BIG SPRING RECHARGE AREA

SOLE SOURCE AQUIFER PETITION

ADDENDUM

Re: Big Spring Recharge Area
Sole Source Aquifer Petition
Response to EPA Comments

Figure 2

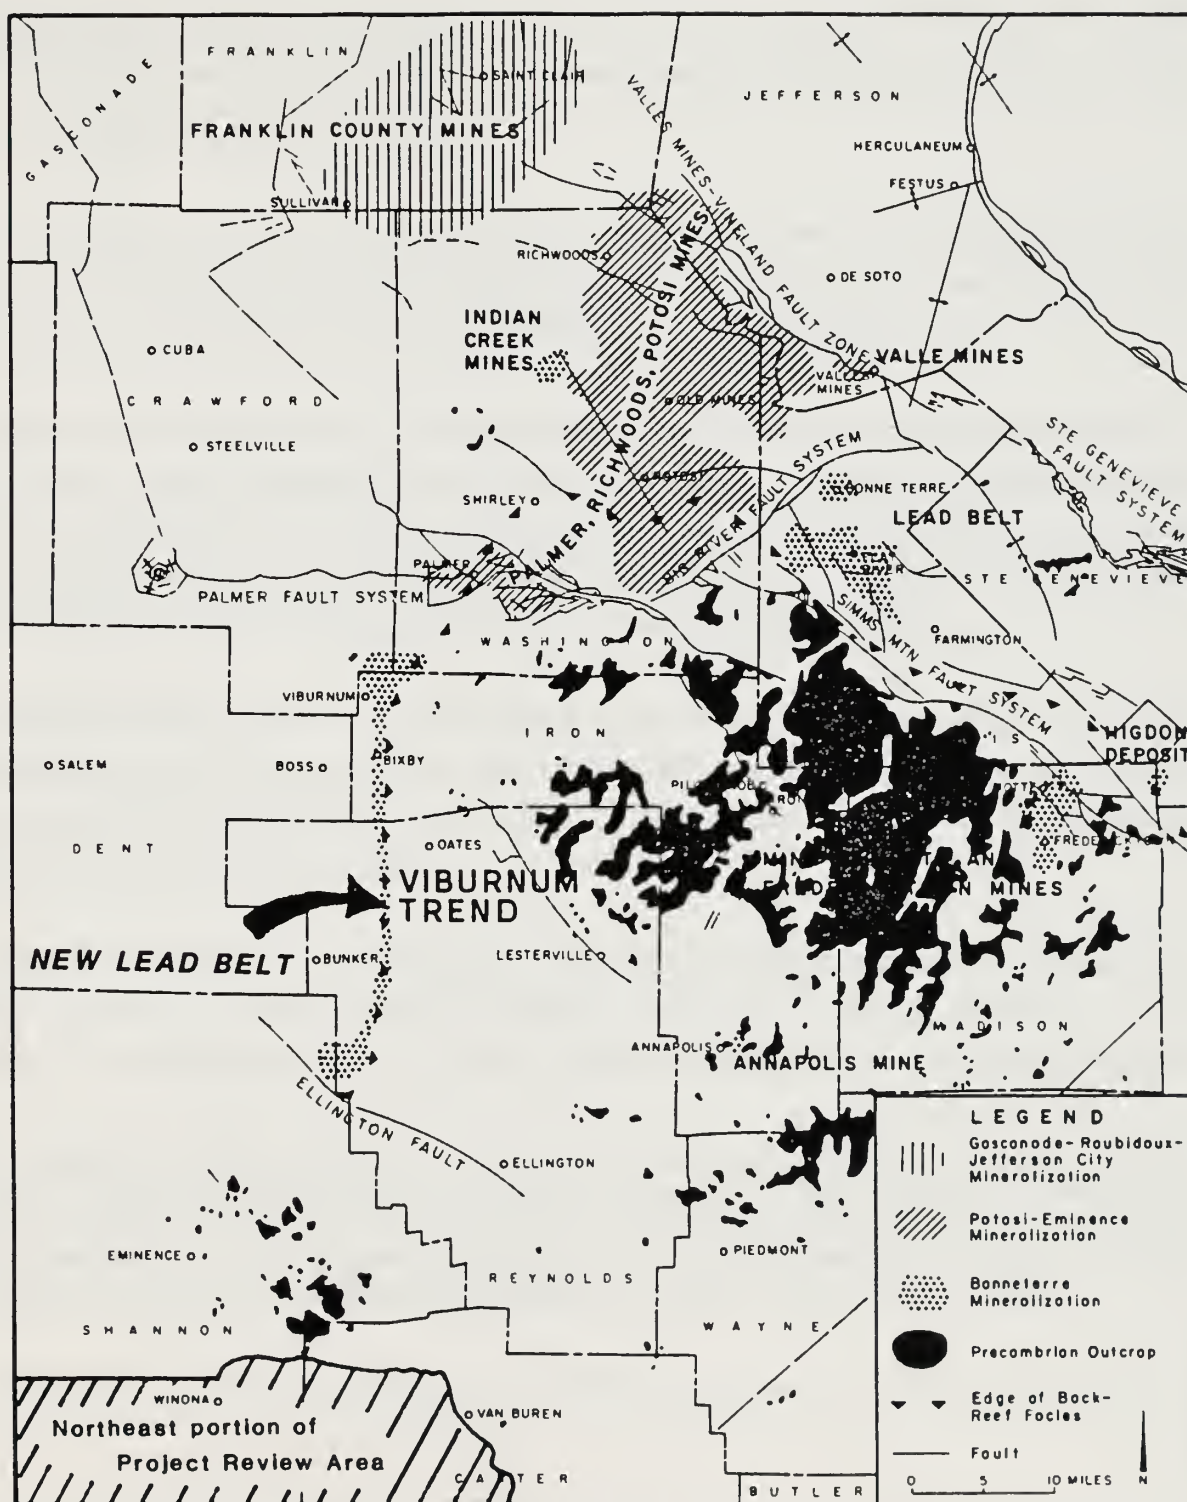
Comment No. 3: *A map showing the location of the "New Lead Belt" with respect to the petitioned area should be included.*

A map of the Southeast Missouri Lead District showing the relationship of the Project Review Area to the "New Lead Belt" is shown on Figure 2 of this addendum.

Figure 1
RELATIONSHIP OF
SCENIC RIVERWAYS TO
PROJECT REVIEW AREA

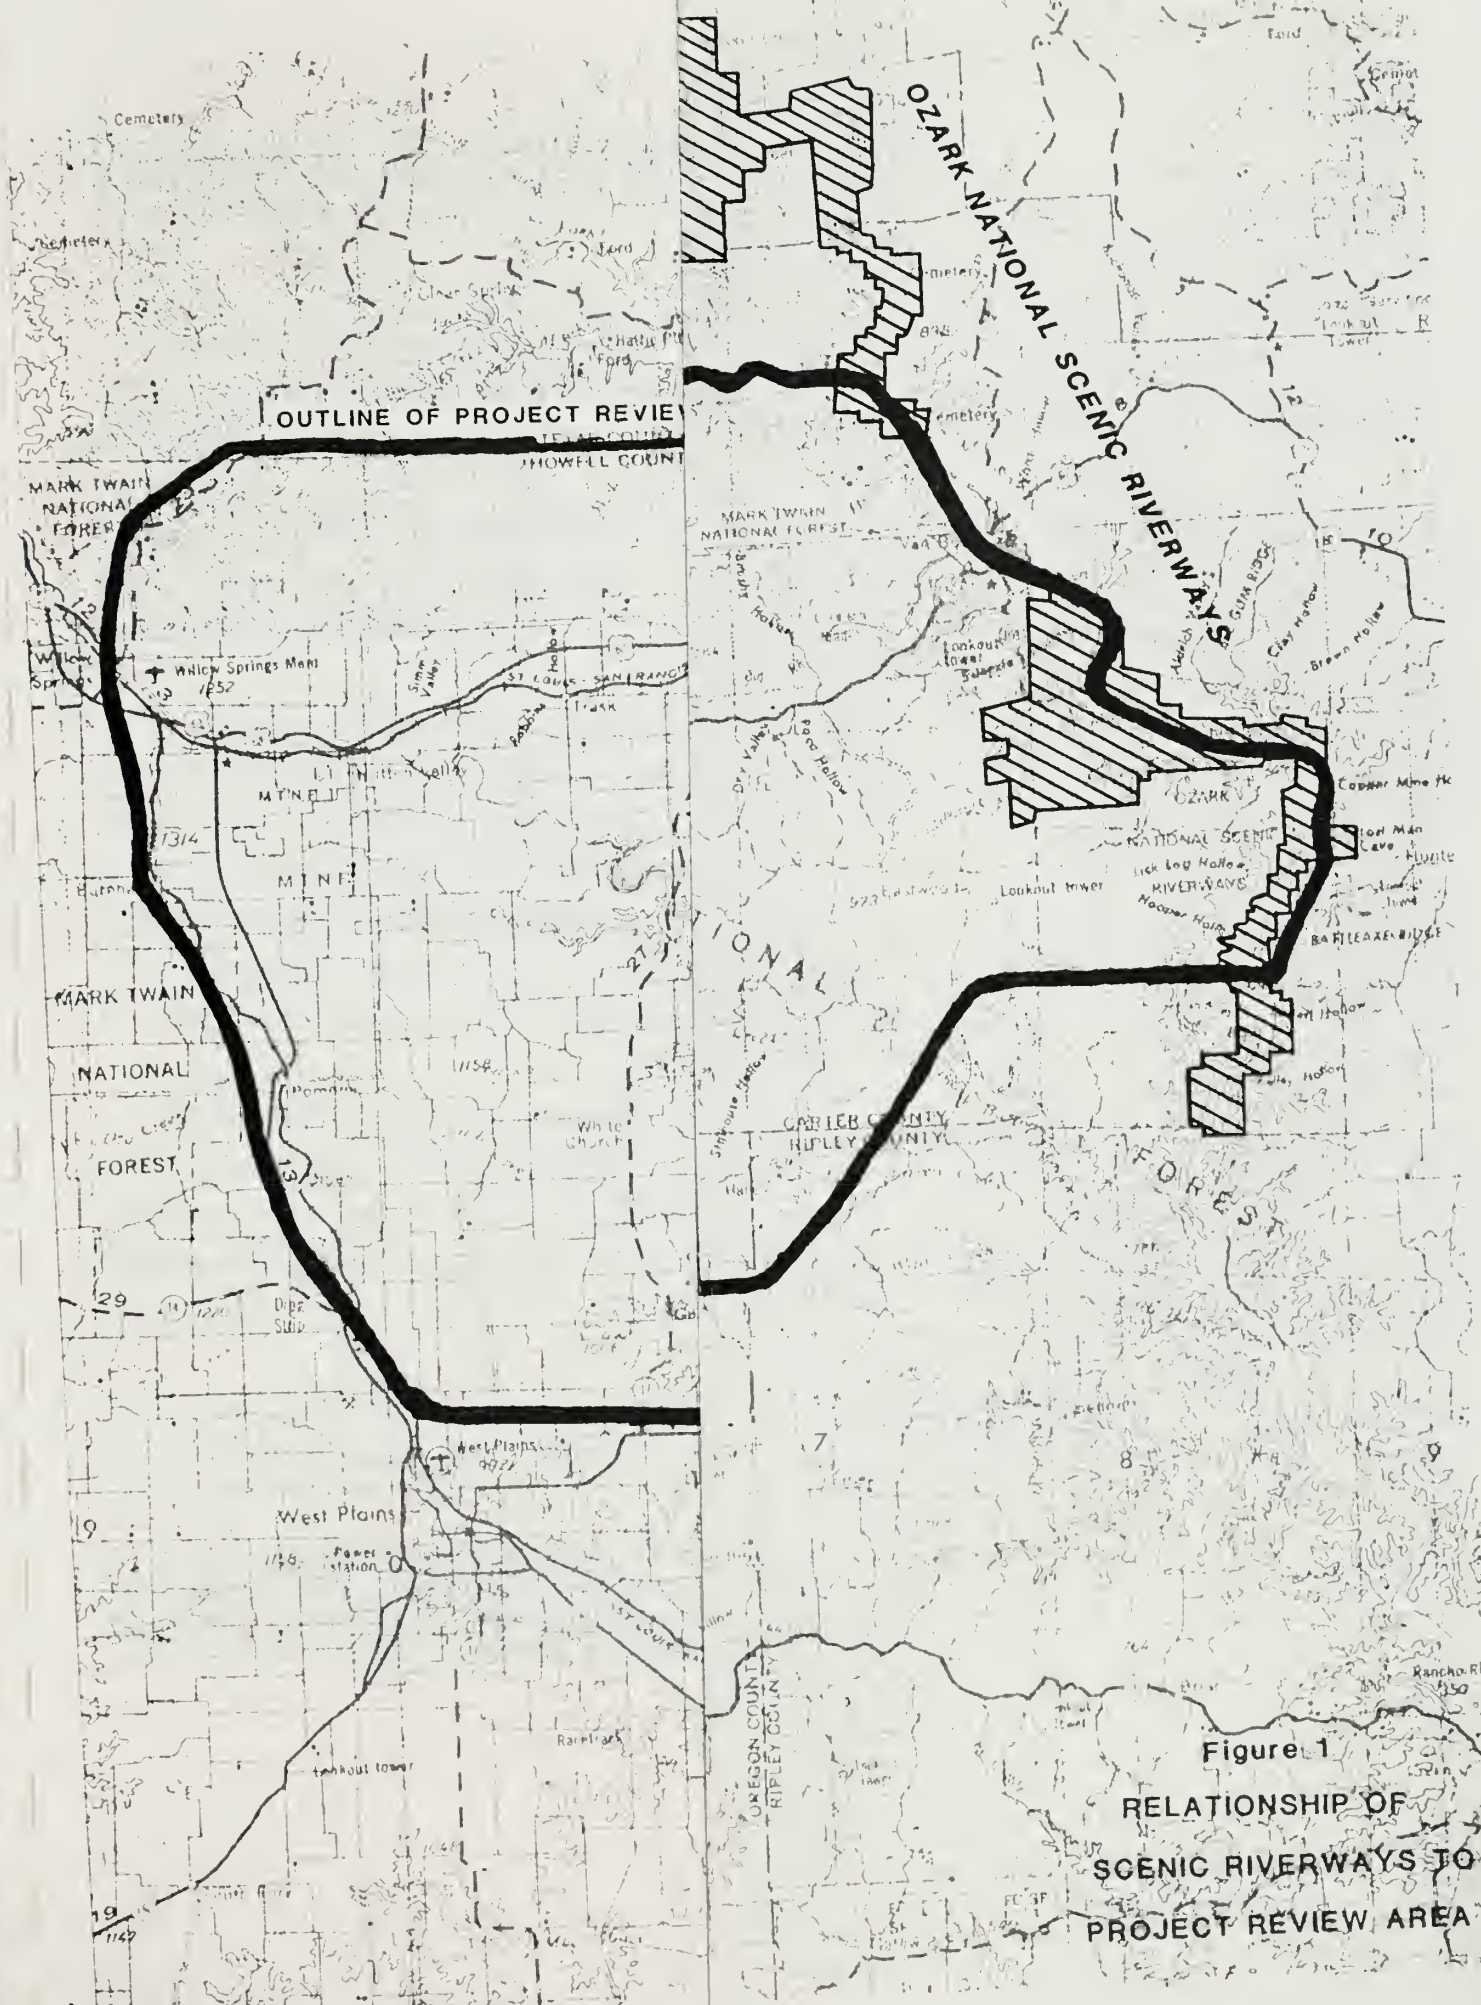
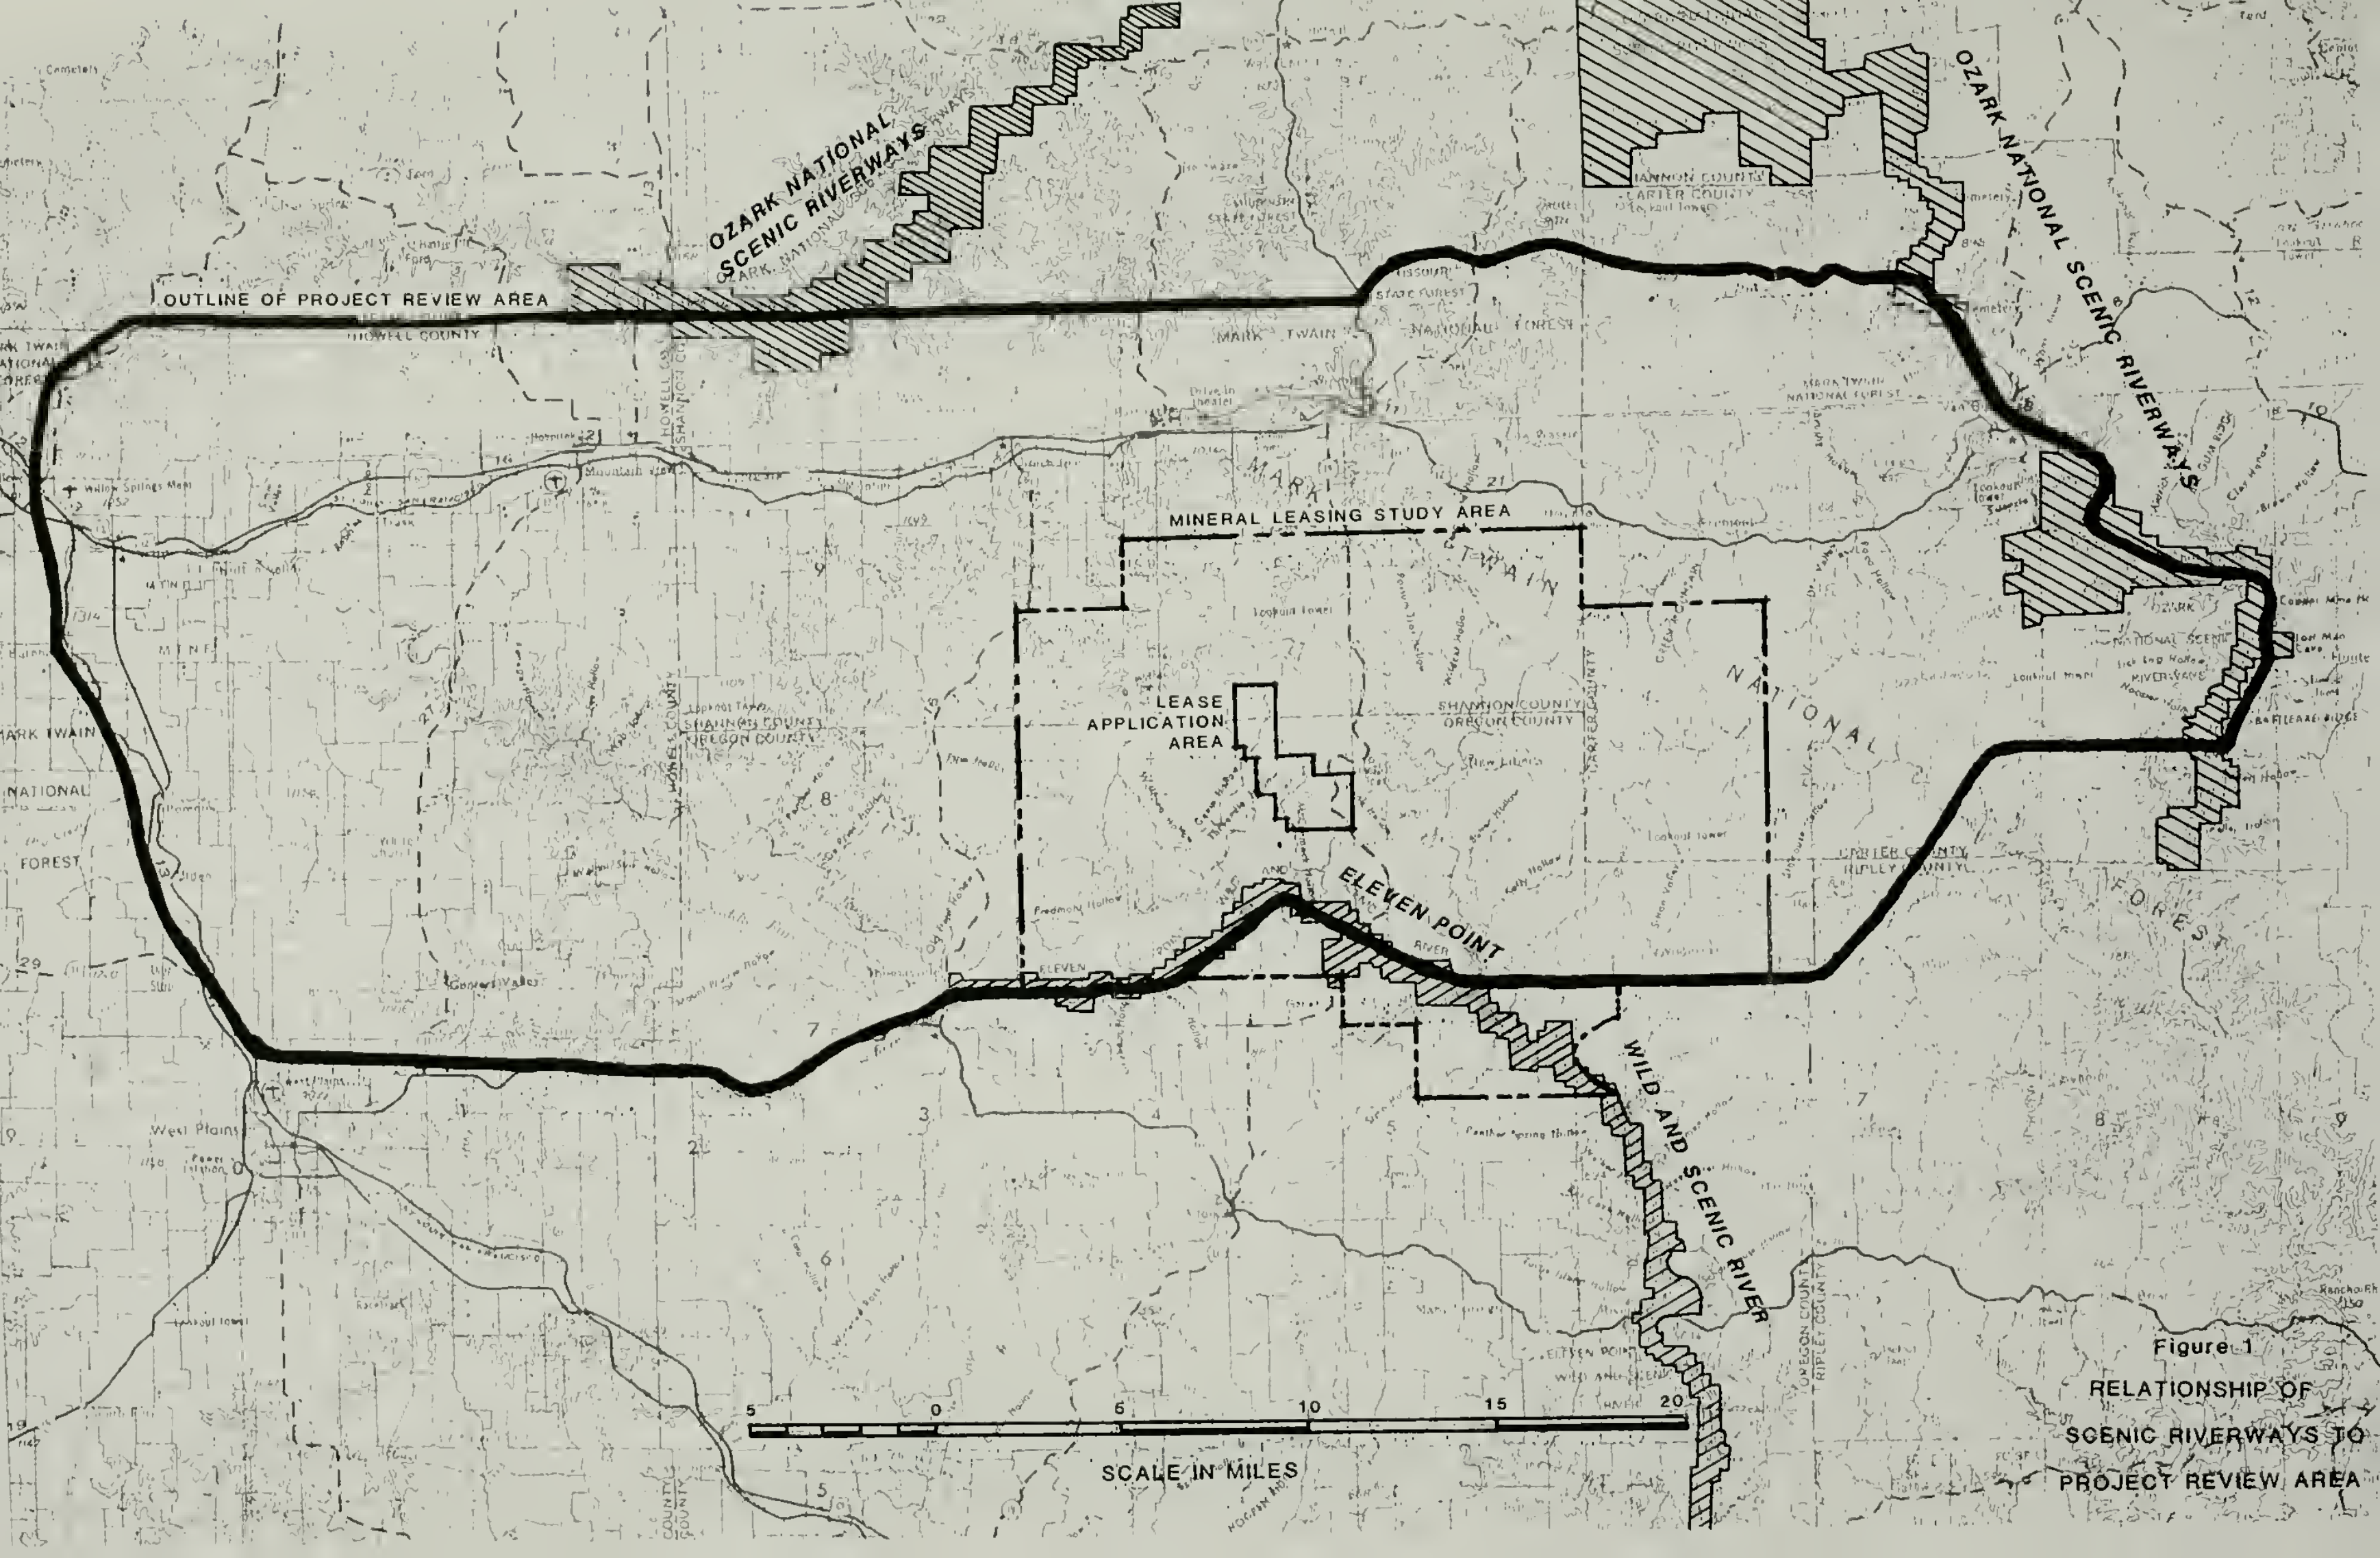
Comment No. 1: *A map indicating the boundaries of the Ozark National Scenic Riverways in relation to the petitioned SSA boundaries should be included.*

Comment No. 4: *Please indicate the scale for the map diagrams.*

Figure 1 of this Addendum displays the boundaries of both the Ozark National Scenic Riverways and the Eleven Point Wild and Scenic River and their relationship to the Project Review Area.

The scale of all maps in the initial petition and in this addendum is 1:250,000. The scales were inadvertently omitted from the maps in the petition dated October, 1989. A graphic scale drafted on Figure 1 of this addendum is applicable to all the maps in the original petition document.
